RAI No.	Section	Issue	Regulatory Link	Discussion	Path Forward
CH-22	Section 7.4 Sensitivity Analysis	Details of Sensitivity Analysis Not Included	10CFR20.2002(d)	Doses of 2.9 mrem for Acute Well-Driller, 3.0 mrem for Chronic Well-Driller, and 16 mrem for the Construction Intruder are provided but the details are not provided in an Attachment. Details are necessary because it is unclear what the concentration and dilution assumptions are for these scenarios.	Please provide the detailed calculations for these doses as were provided for the other scenarios.
<b>Response Summary:</b> Detailed calculations for each of the three scenarios are attached.					
<b>Response Detail:</b> In all cases the bounding concentration was based on 100 percent of the activity being from 3000 pCi/g of total uranium, with the isotopic composition based on existing sample data.

**Overall Comments on Request for Additional Alternate Disposal Approval and Exemptions for Specific Hematite Decommissioning Project Waste at US Ecology Idaho**

Figure 1 to Appendix G of HDP-TBD-WM-906, Sampling Results for the Process Buildings Underground Piping and Site Sewer Lines

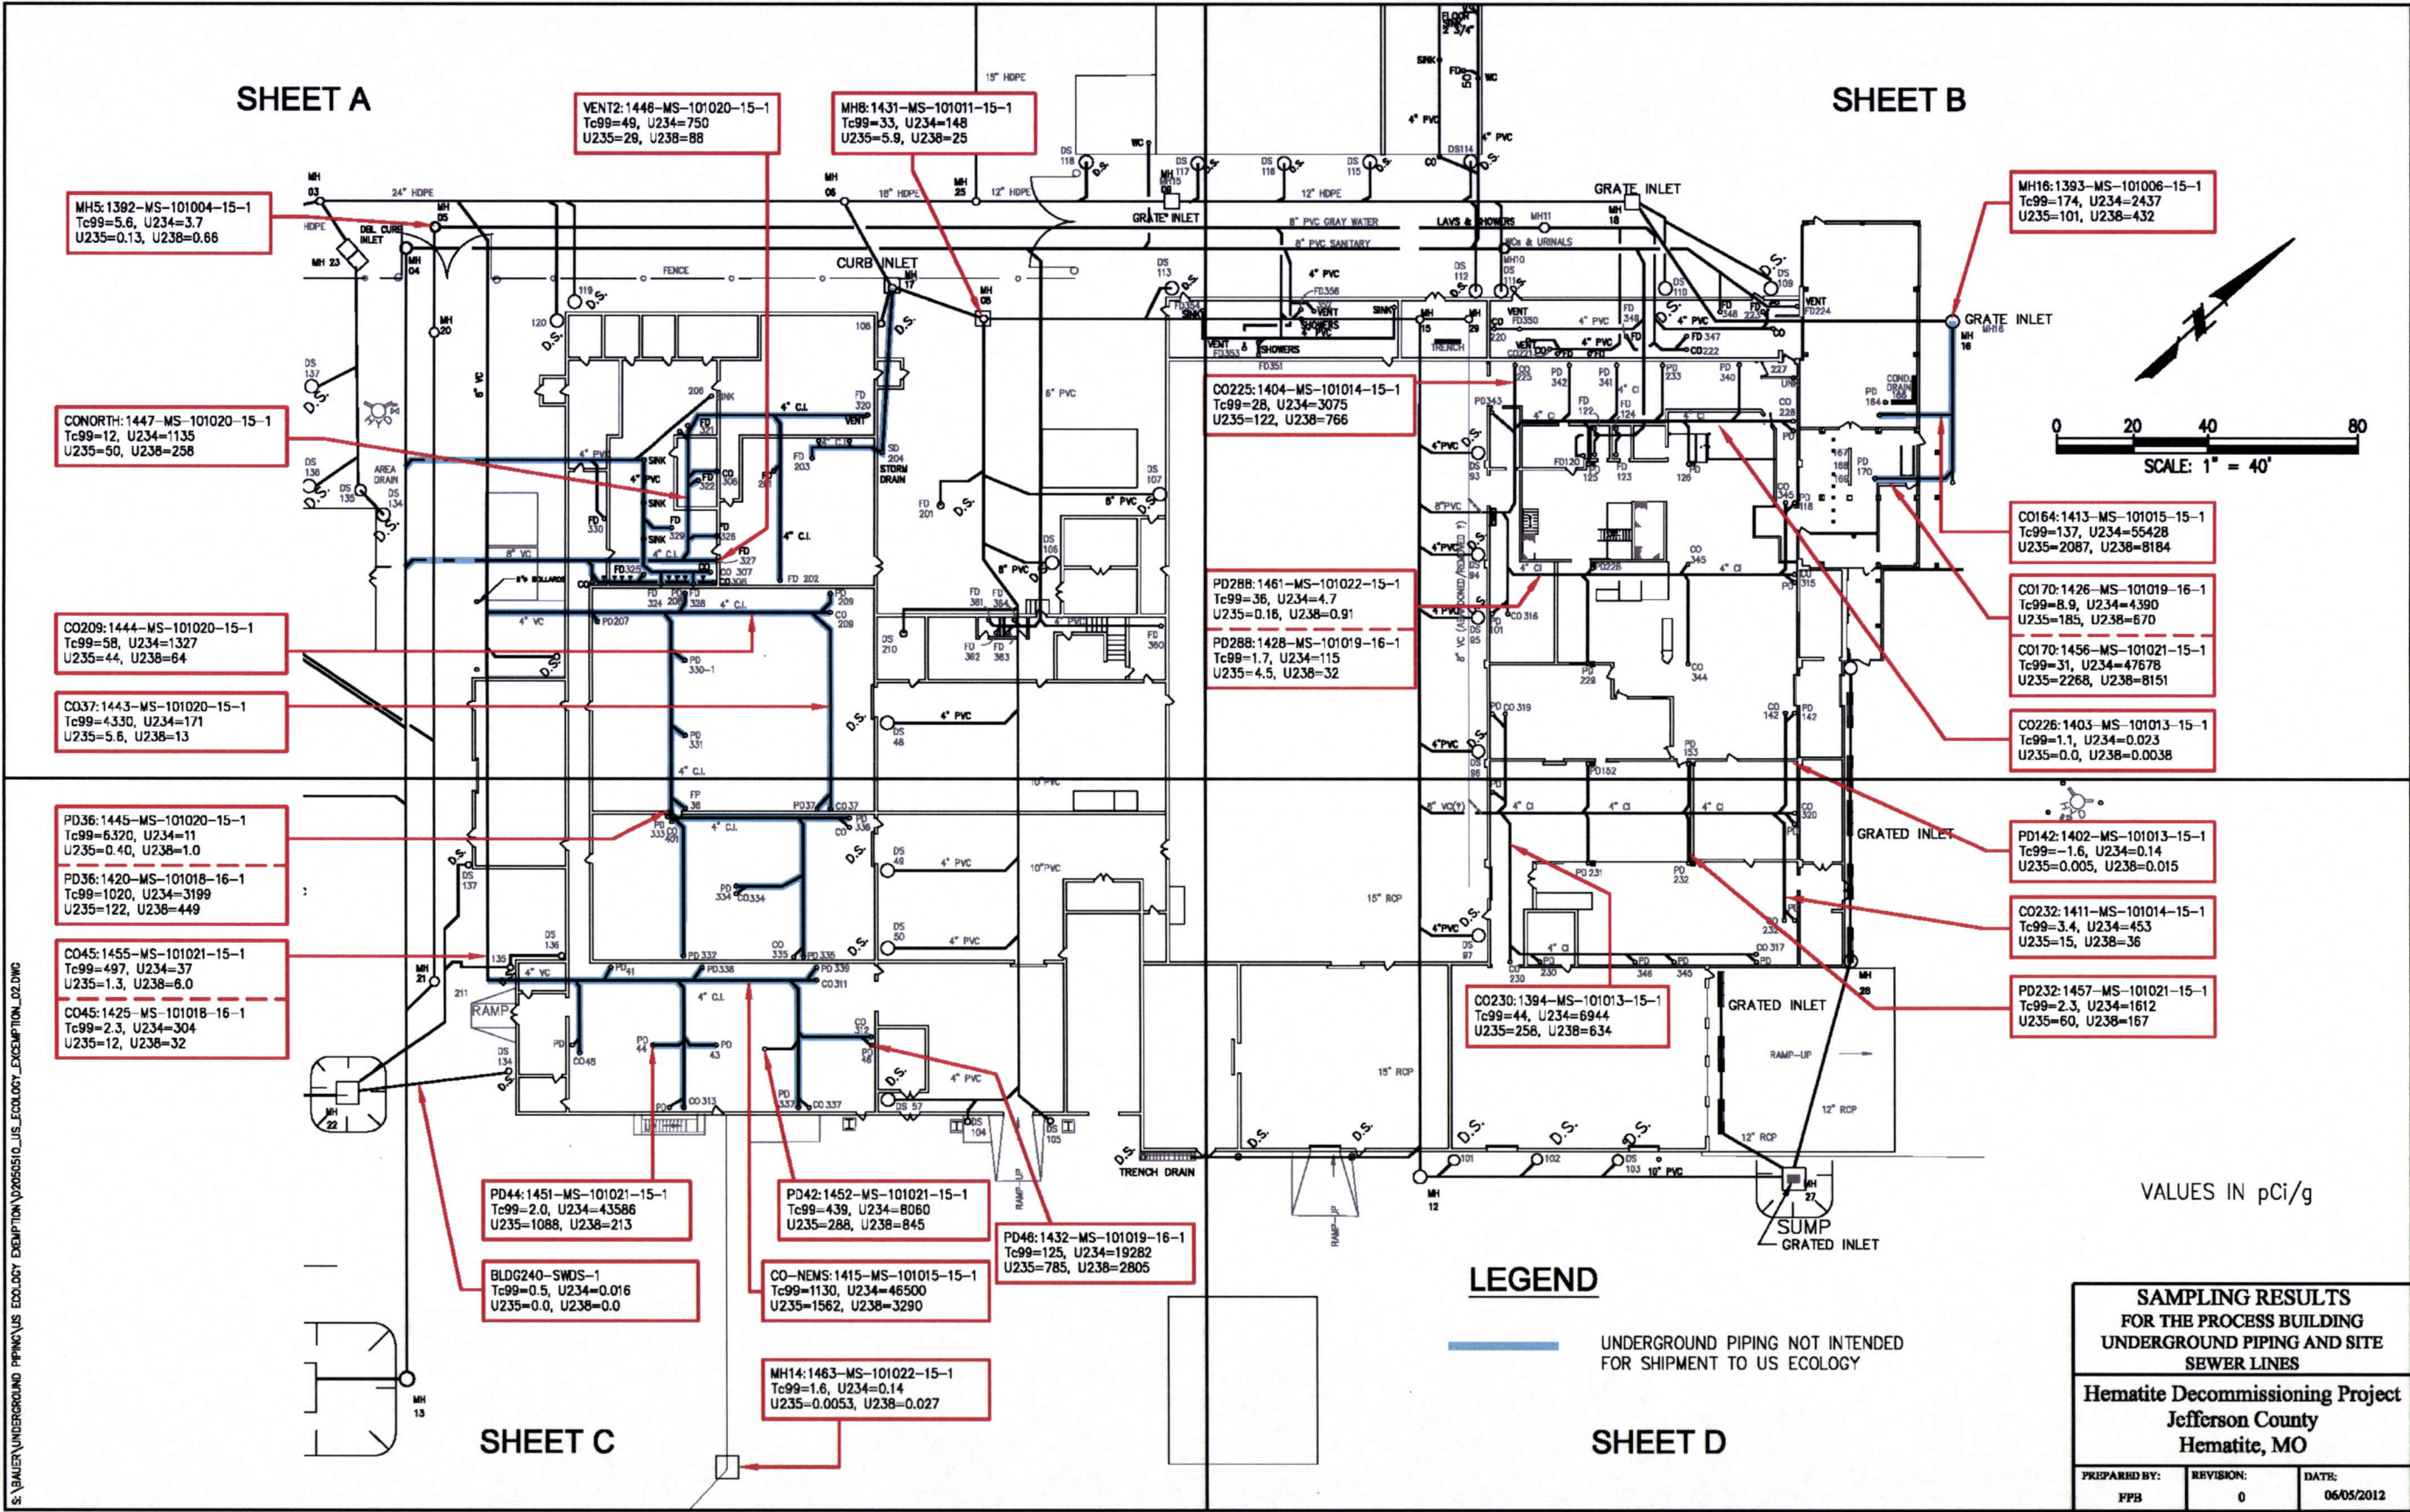
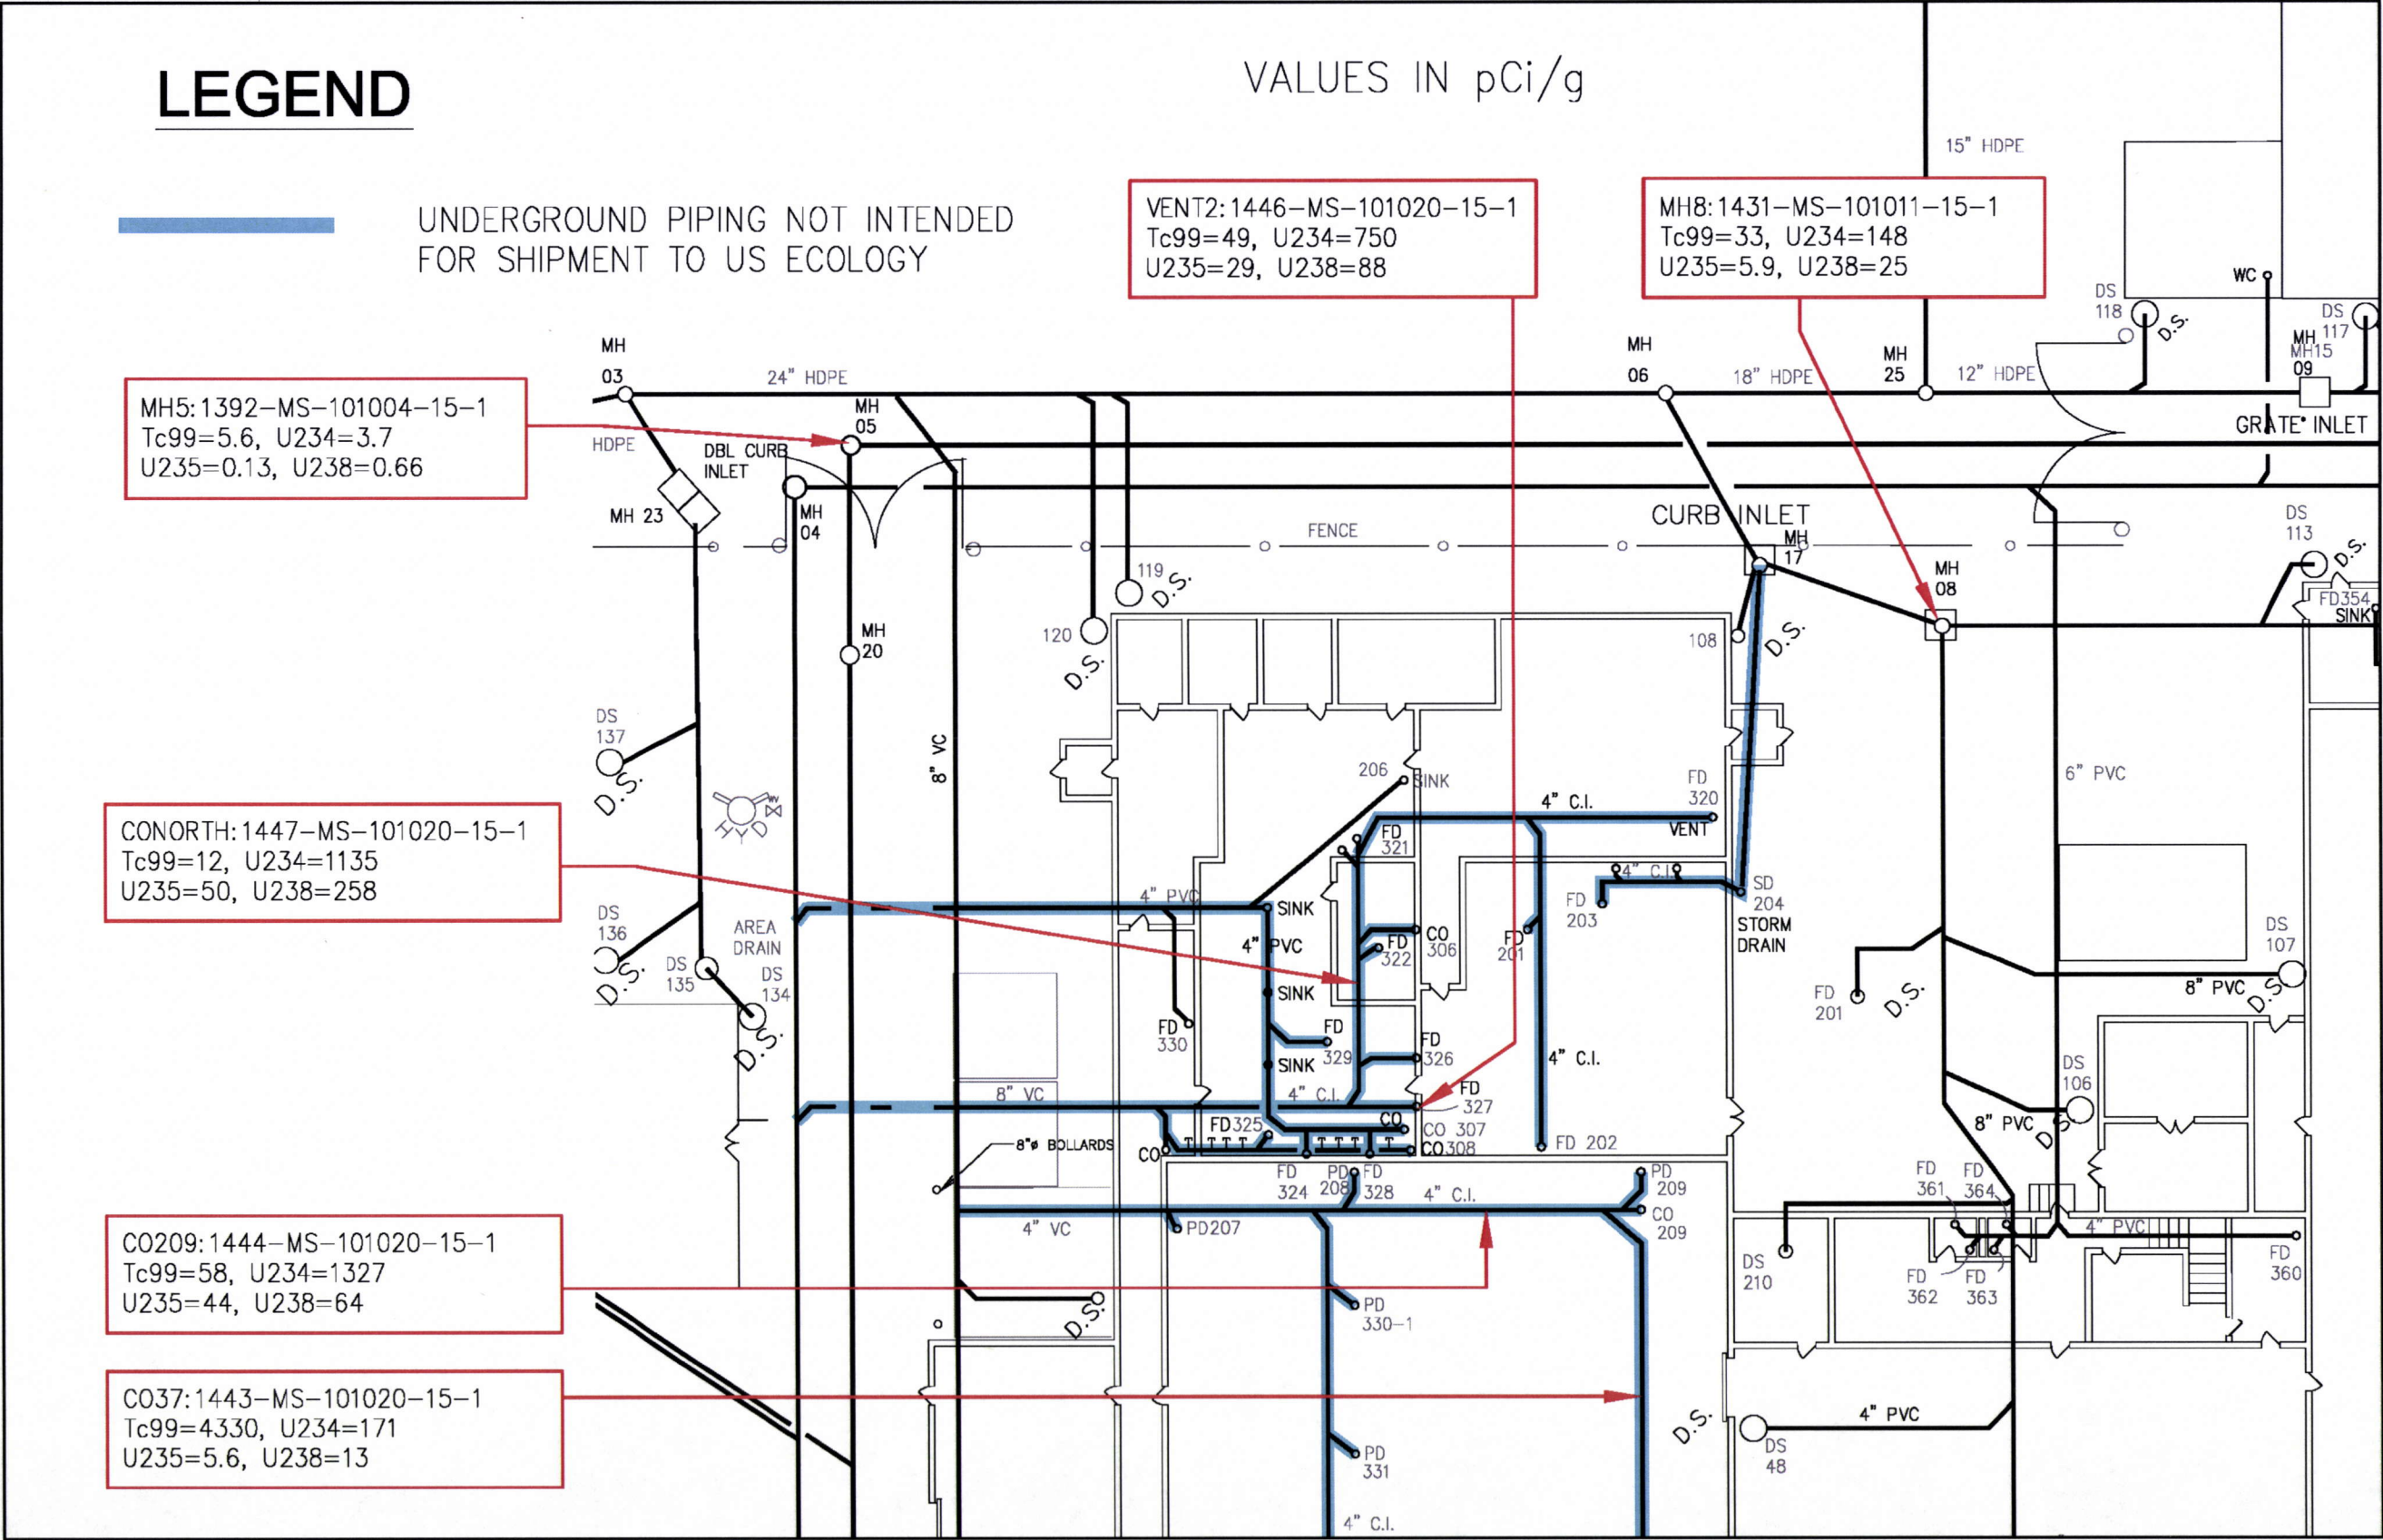
RAI No.	Section	Issue	Regulatory Link	Discussion	Path Forward
SA-7	HDP-TBD-WM-906 Section 7.1 and Appendix G	TBD Section 7.1 and App. G Figure 1 are not descriptive of piping location.	10CFR20.2002(a)	The link between piping to area and building populations is unclear.	Provide additional graphics or tables to clearly segregate piping and identify the location.
<b>Response Summary:</b> Additional graphics are provided to provide visual reference between					
<b>Response Detail:</b> Appendix F contains the specific piping included in each of the piping group designation (such as “Building 240 Middle System”) identified in Tables 7-4 and 7-5 of Section 7.1 of HDP-TBD-WM-906. In Appendix F of HDP-TBD-WM-906, the ‘From’ and ‘To/Toward’ columns contain identifiers that can be located on Figure 1 of Appendix G to HDP-TBD-WM-906 for the piping groups identified in Tables 7-4 and 7-5 of Section 7.1 of HDP-TBD-WM-906. Figure 1 to Appendix G has been broken into quadrants to facilitate it use, as provided below. A number on the figure without an associated alpha character (e.g., 203) should be read as being associated with ‘FD’ (e.g., FD 203). In some the entire words may be spelled out instead of just the alpha character (e.g., ‘204 Storm Drain’ instead of ‘SD 204’).

RAI No.	Section	Issue	Regulatory Link	Discussion	Path Forward
ENCL-5	Section 5.1	Criticality Safety Assessment, FNMCP & Physical Security	10CFR74.11	It is stated that the waste in the soil, slabs, concrete, asphalt, or HVAC equipment would consist of U-235 at enrichment levels averaging below 10%.	Provide the basis for concluding that there will be any U-235 in the soil, slabs, concrete, asphalt, or HVAC equipment enriched to levels above 5%.
<b>Response Summary:</b> Existing characterization data has identified					
<b>Response Detail:</b> Table 4-1 from HDP-TBD-WM-906 provides a summary of the average enrichment measured for each waste stream component. These range from 3.4 to 5 percent. While this represents the average enrichment, there are individual samples that indicate the presence of materials with a higher enrichment. For example, four concrete samples (1, 2B, 13 and 14) have enrichments exceeding 5 percent (8.2, 18.7, 9.4 and 15.6 percent), as listed in Table 1-2 of NSA-TR-HDP-11-11 (Attachment 10 to HEM-12-2). Other examples are internal pipe sample results listed in the figure associated with RAI SA-7 above.
